S E R V I C E N O T E

6031A Autoranging DC Power Supply

Serial Numbers: 3102A02221 / 3140A02460

Modification using RTV to prevent W8 Ribbon Cable disconnect.**Duplicate Service Notes:**

Figure 1

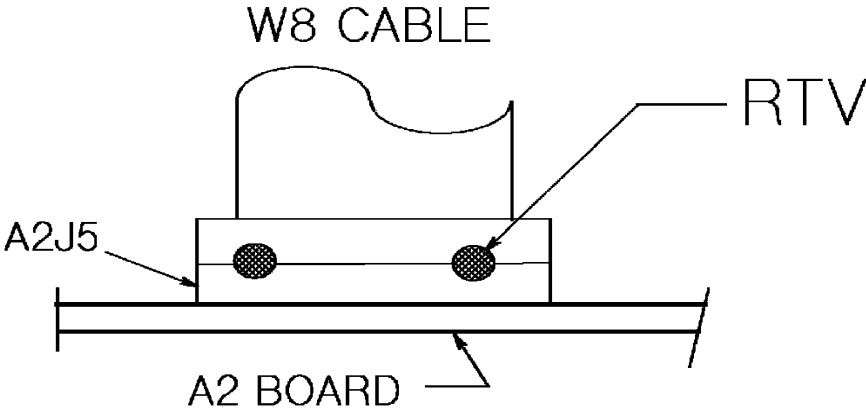
The W8 ribbon cable connecting the A1 main board assembly to the A2 Control board assembly may vibrate loose during transportation. This only involves units with serial numbers inclusive of those listed above.

Reconnect the W8 ribbon cable. Use RTV to secure the W8 connector to the J5 mating connector on the A2 assembly. Put a 8 mm (0.313 in) size spot bridging the W8 / J5 connectors. Bridge the connectors with an RTV spot at each end as shown in figure 1.
